Henry Lawson Drive Upgrade

Stage 1A

Addendum review of environmental
factors
November 2022

Figure 1-2: The proposed modification

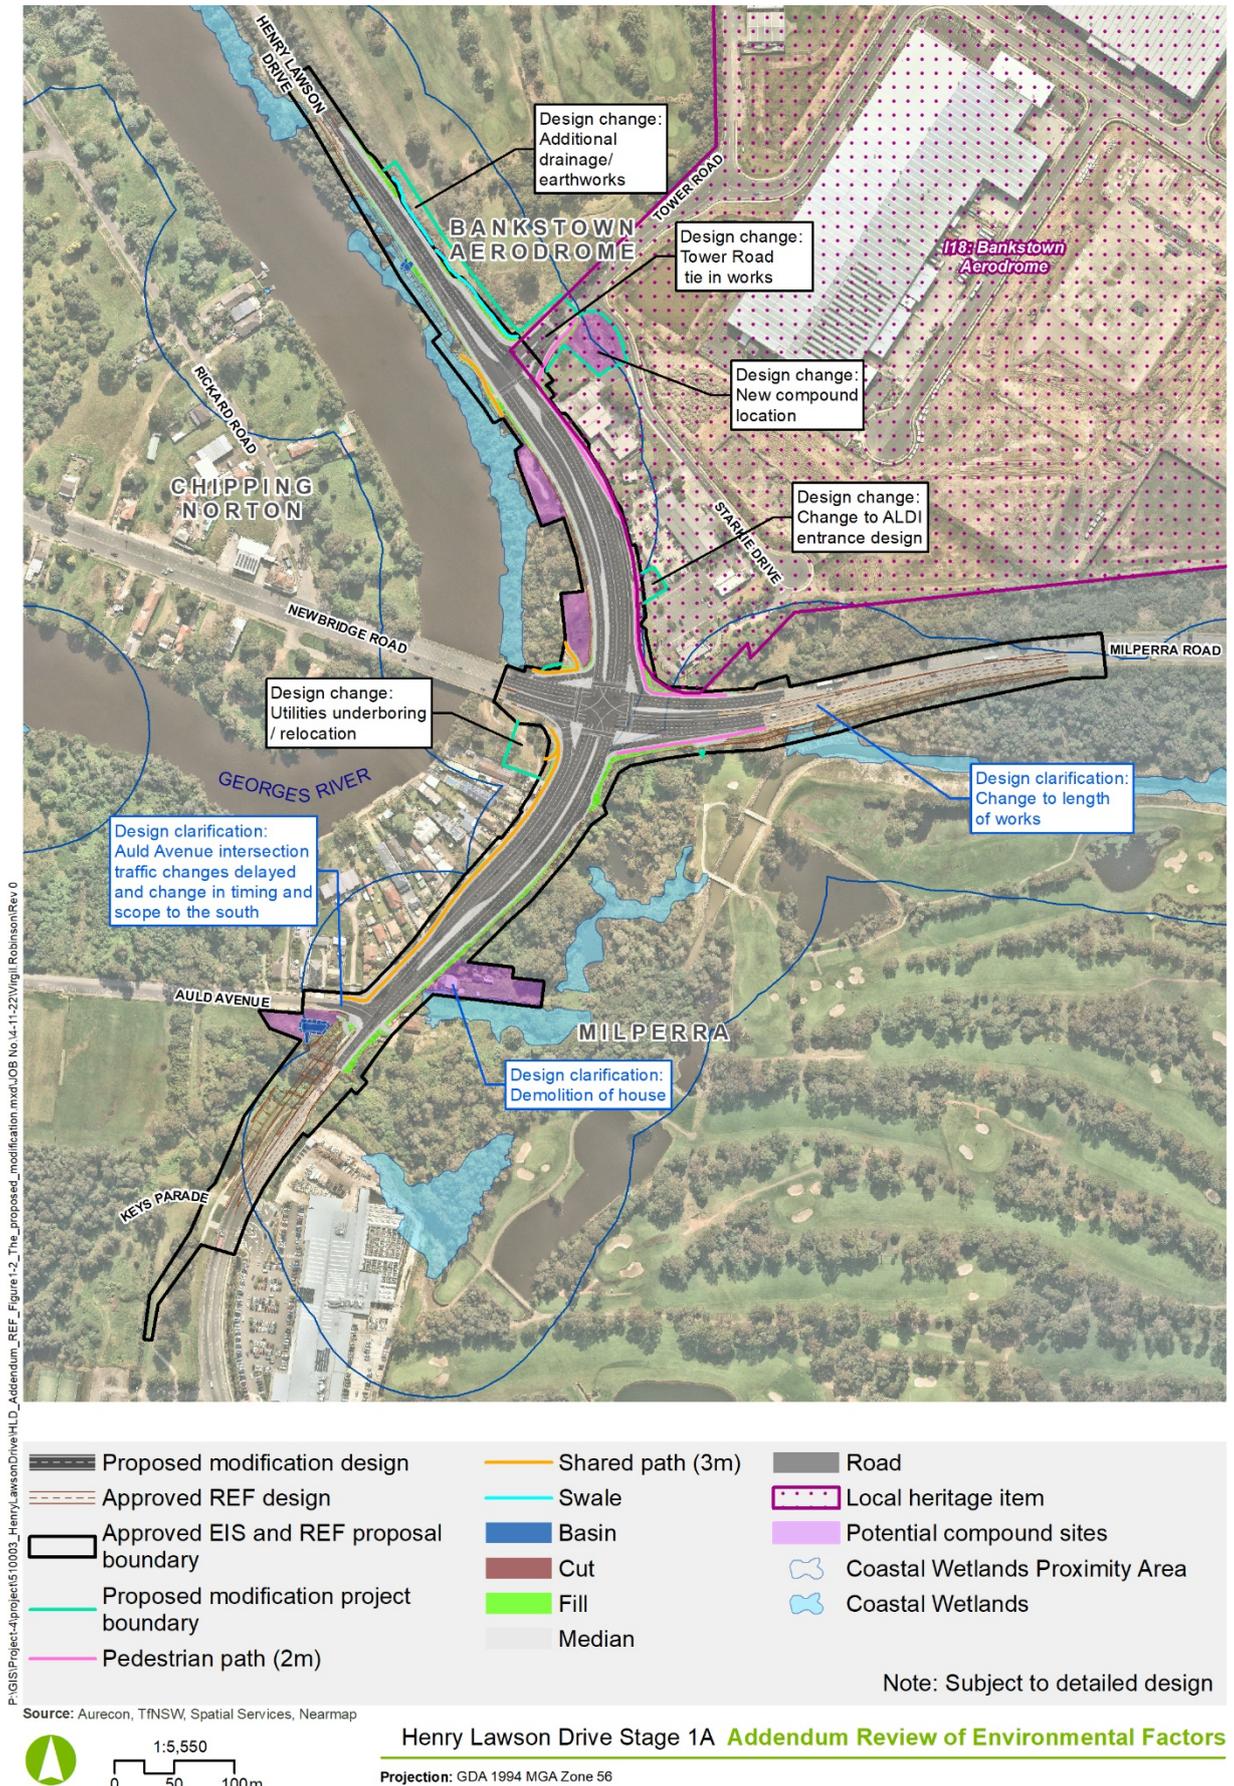
The key features of the proposed modification are shown in Figure 1-2 with further detail provided in Figure 3-1 to Figure 3-6. It should be noted that the proposed modification is not located on and would not require modification to the approved EIS area.

Figure 3-1 Additional drainage and earthworks on the Georges River Golf Course north of Tower Road

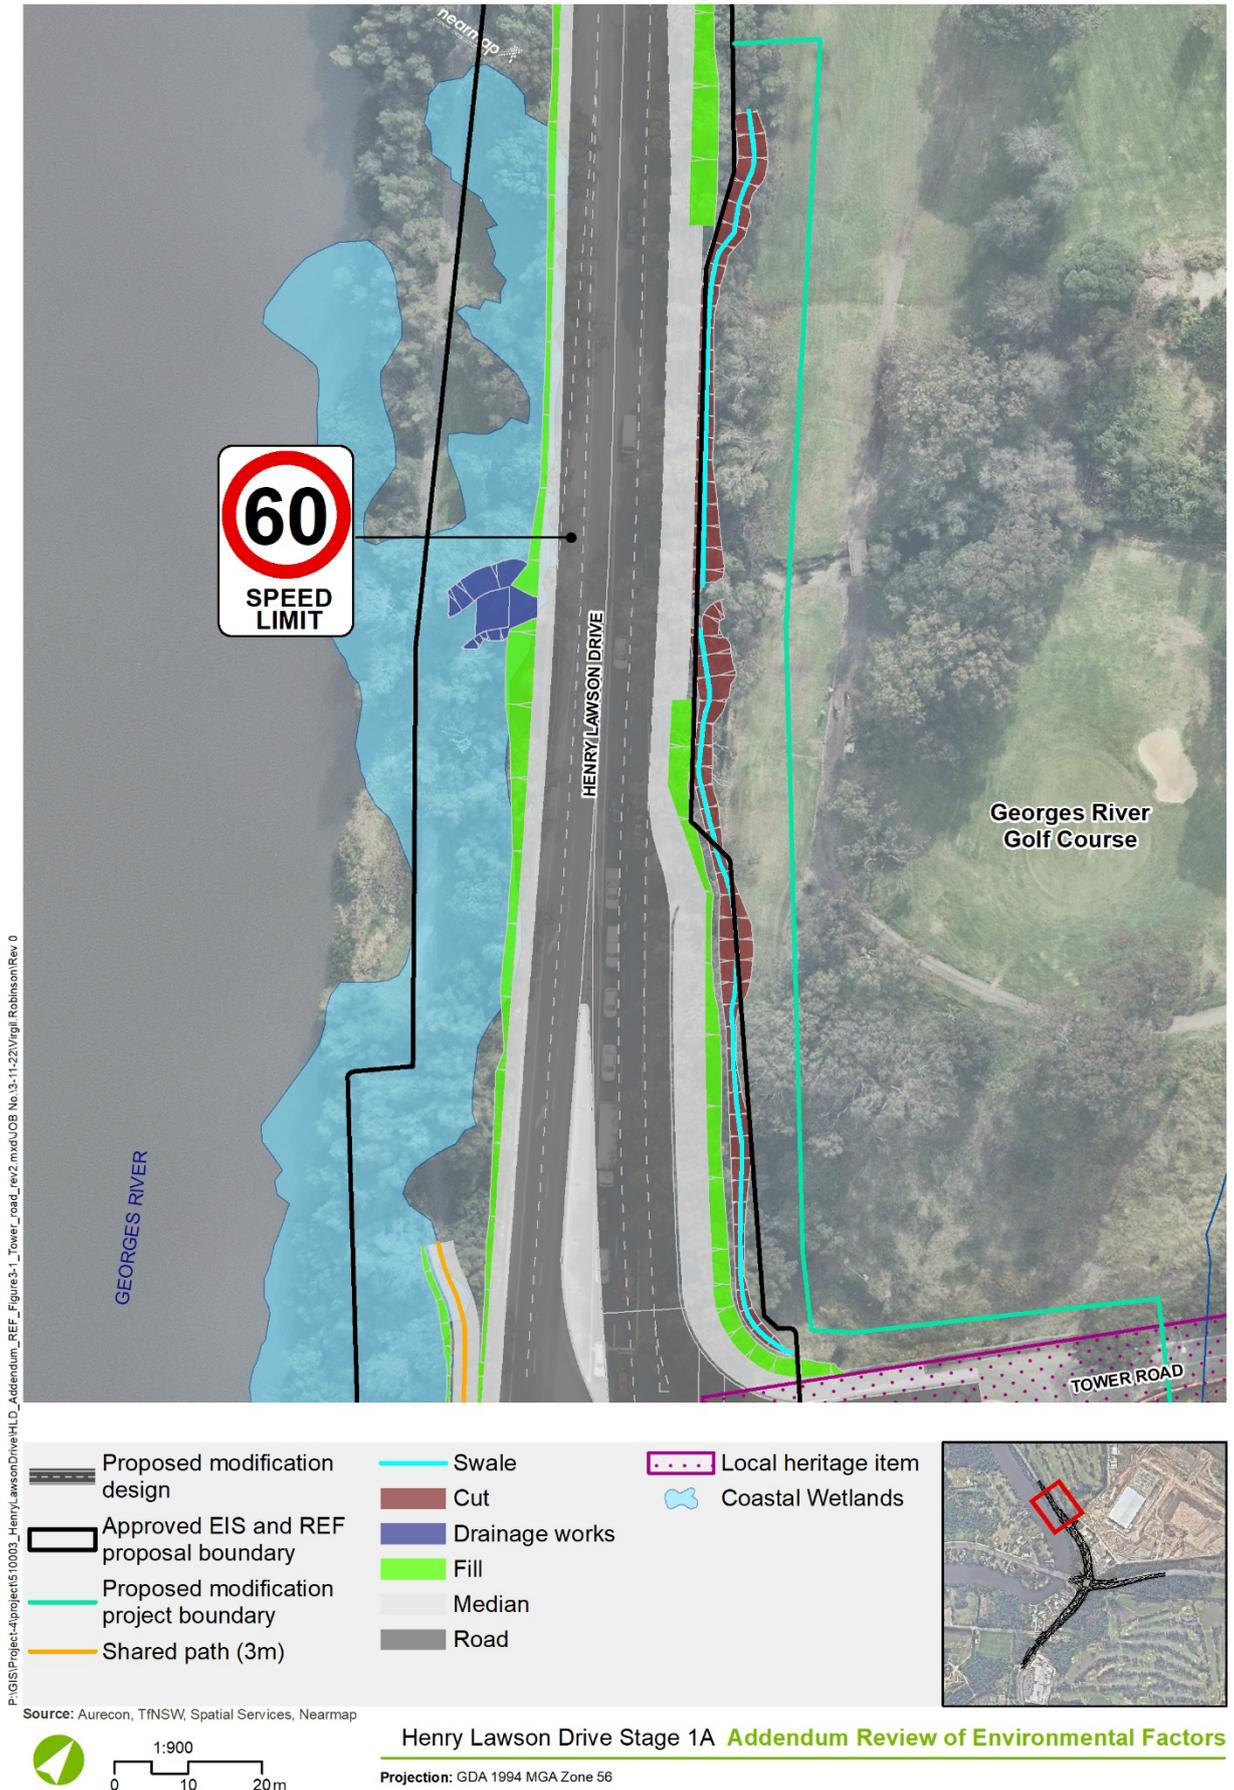
Works in this area would involve culvert replacement, construction of a retaining wall, proposed swale works and additional vegetation clearing as noted in Figure 3-1 below.

Figure 3-2: Proposed modification to the Milperra Road construction area.

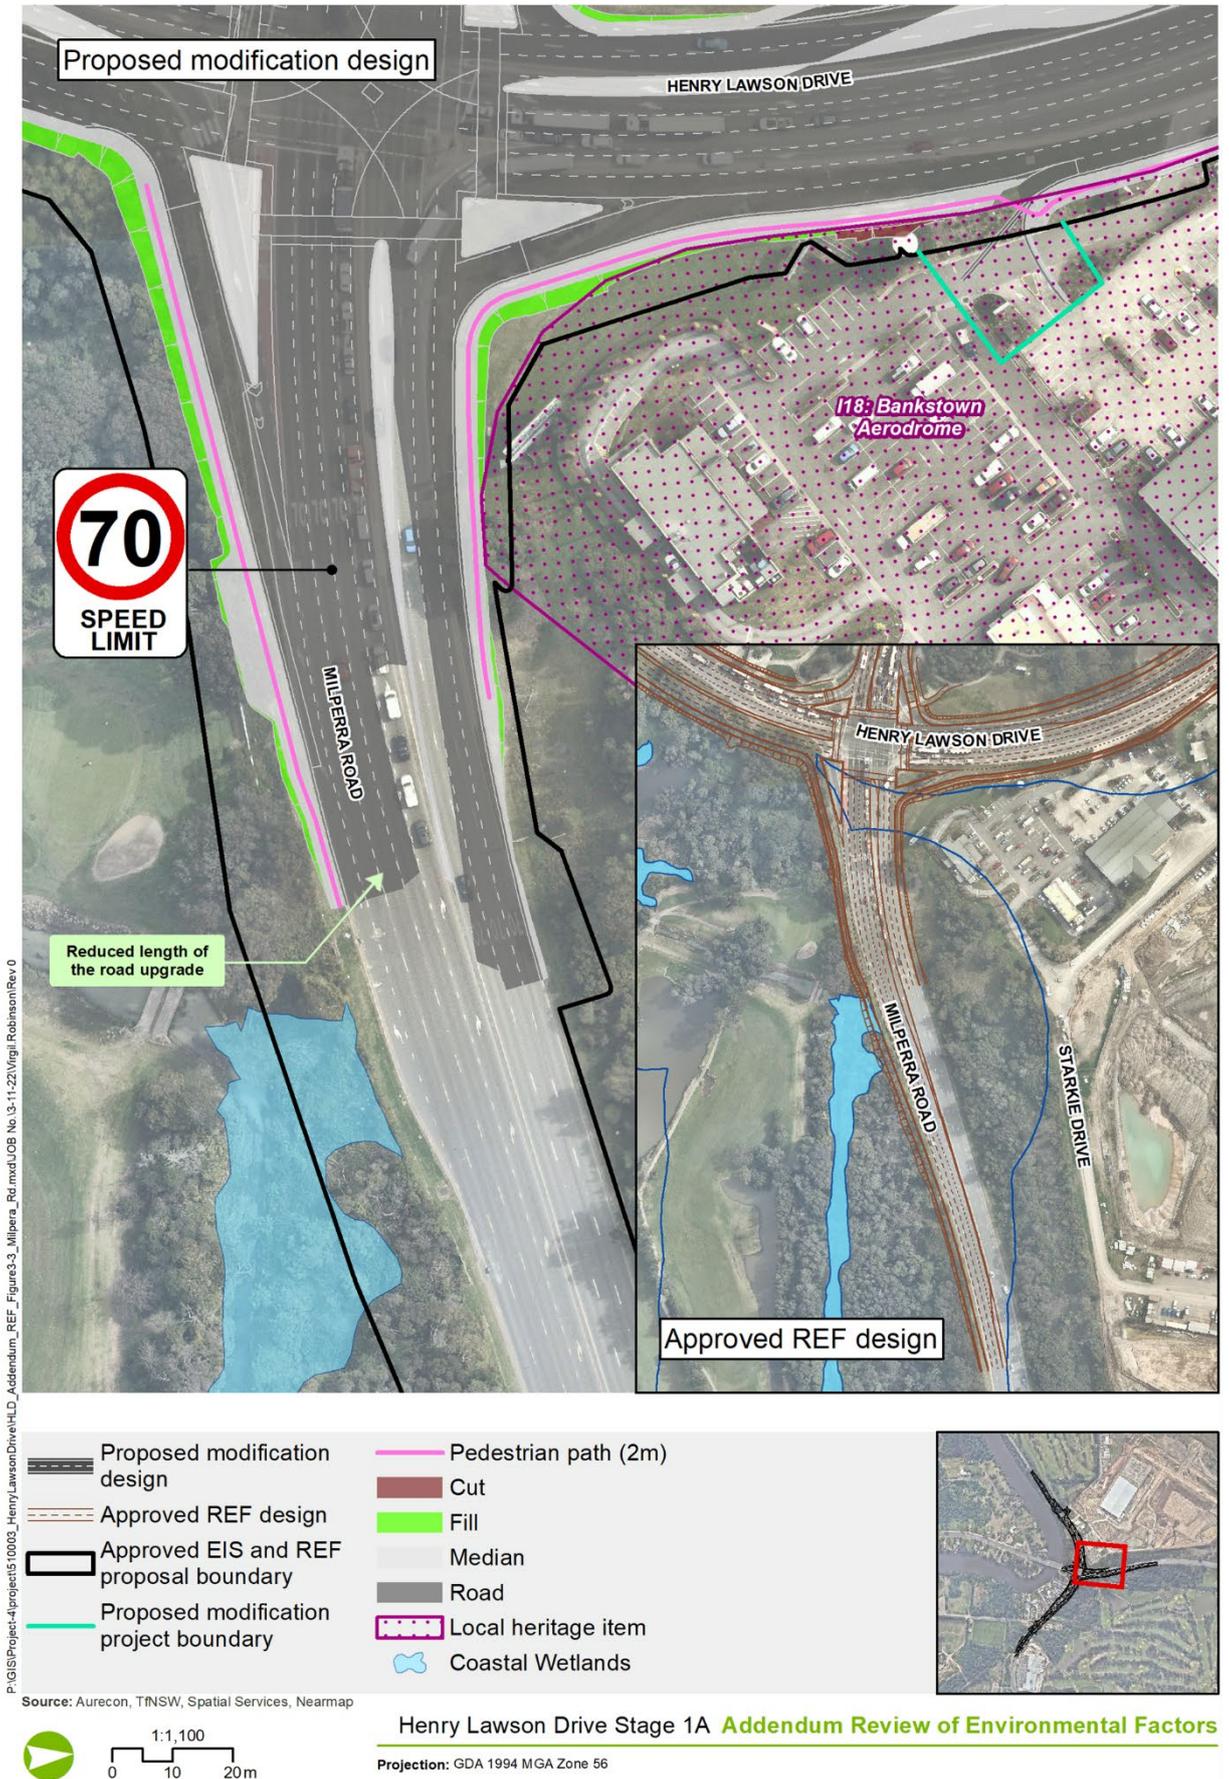
The project REF identified a 480 metre upgrade of Milperra Road. An undetermined Aboriginal land claim exists along Milperra Road. The delivery of the full approved design would be staged subject to the Aboriginal land claim determination as identified in Figure 1-3. Staging of the works would include preliminary works such as excavation, pavement works and finishing works such as line marking.

Figure 3-4 Changes to the scope and timing of works to Auld Avenue intersection and the Milperra Drain bridge

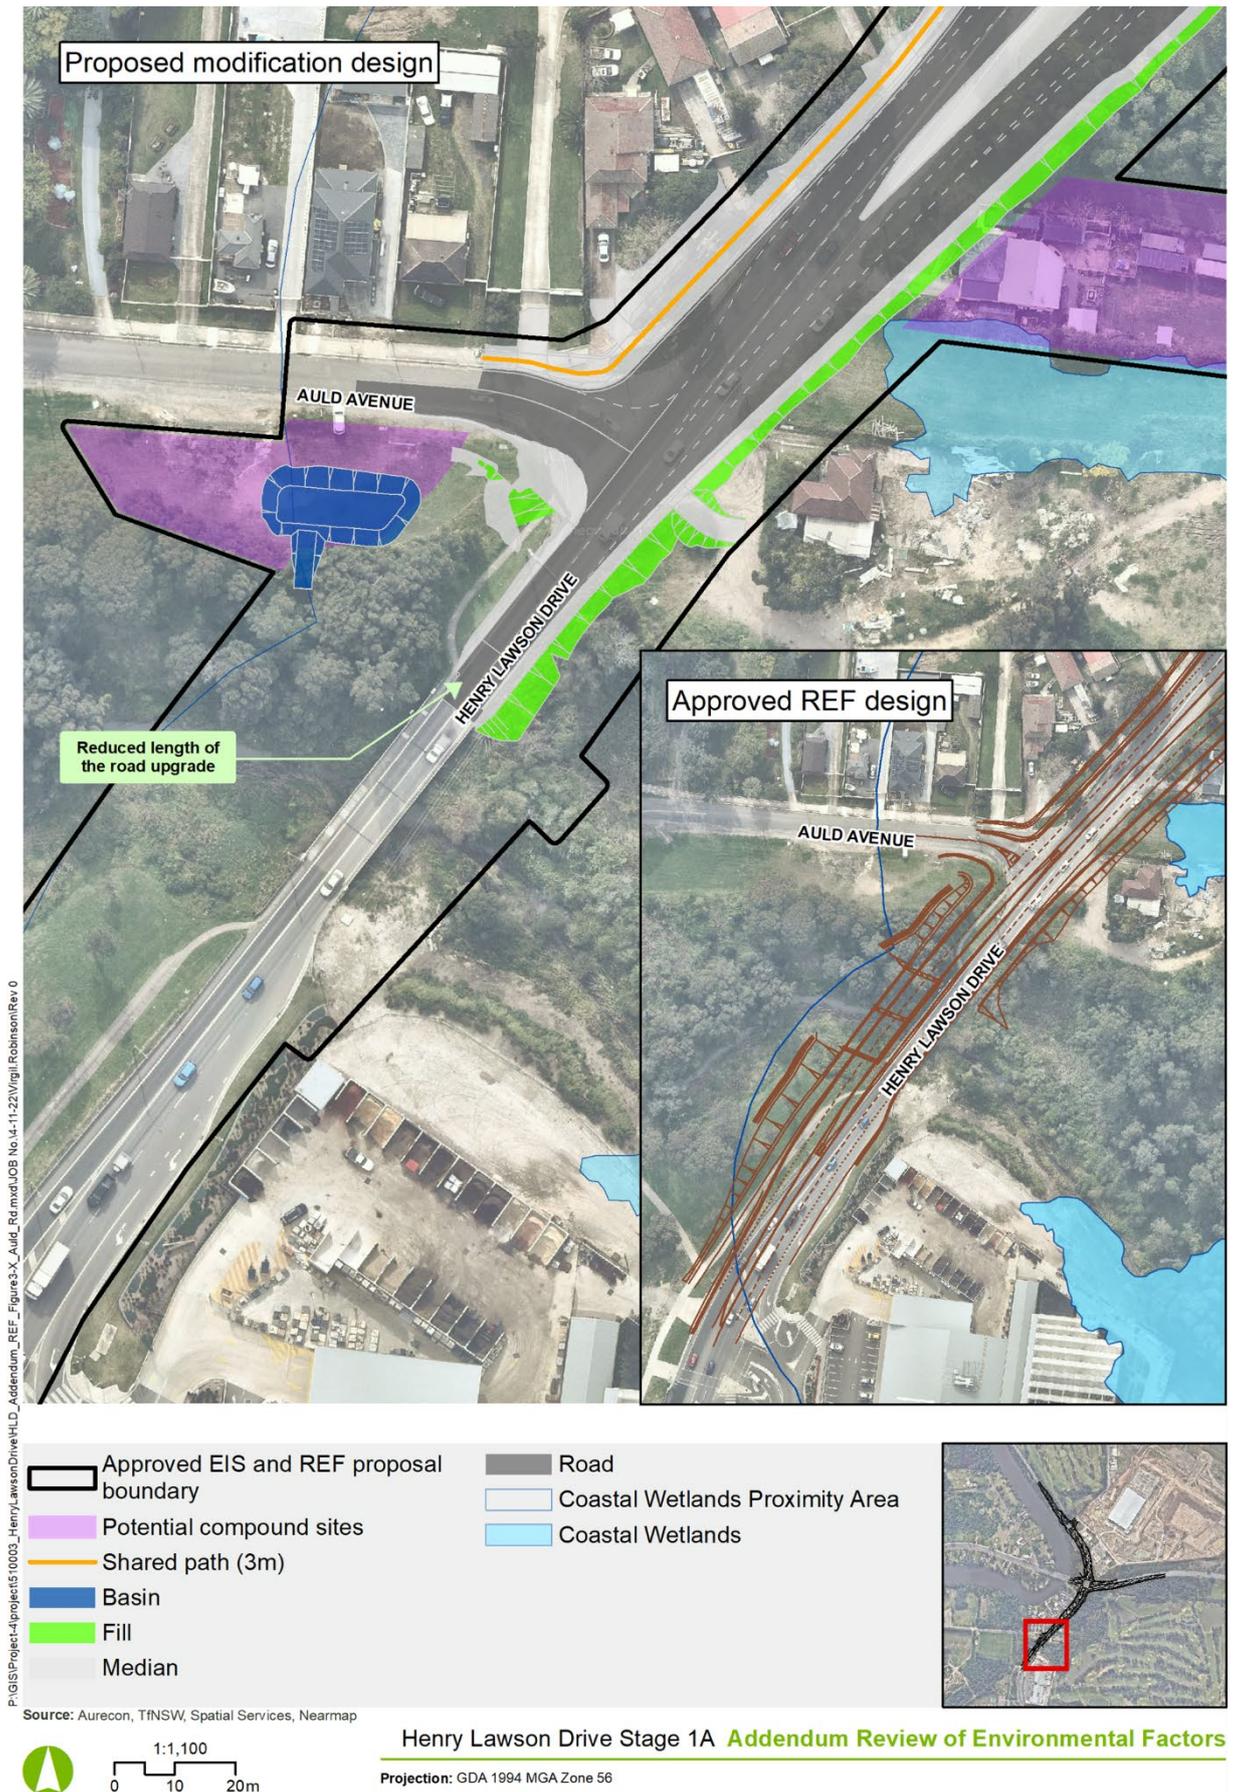
The proposed modification would undertake pavement, earthwork, utilities and new permanent water quality basin (as per the surface water assessment (Appendix F of the project REF) as part of the Stage 1A project but would retain all turning movement in and out of Auld Avenue.

The proposed modification would result in further works to the existing Milperra Drain bridge to improve safety outcomes. This includes the reconstruction of the concrete kerb on the bridge to allow for installation of the new road barrier system to current standards, re-pavement of the bridge and structural strengthening of the bridge deck and girders under the structure. These works are consistent with kerb and pavement works identified across the broader project and no additional environmental impacts are expected.
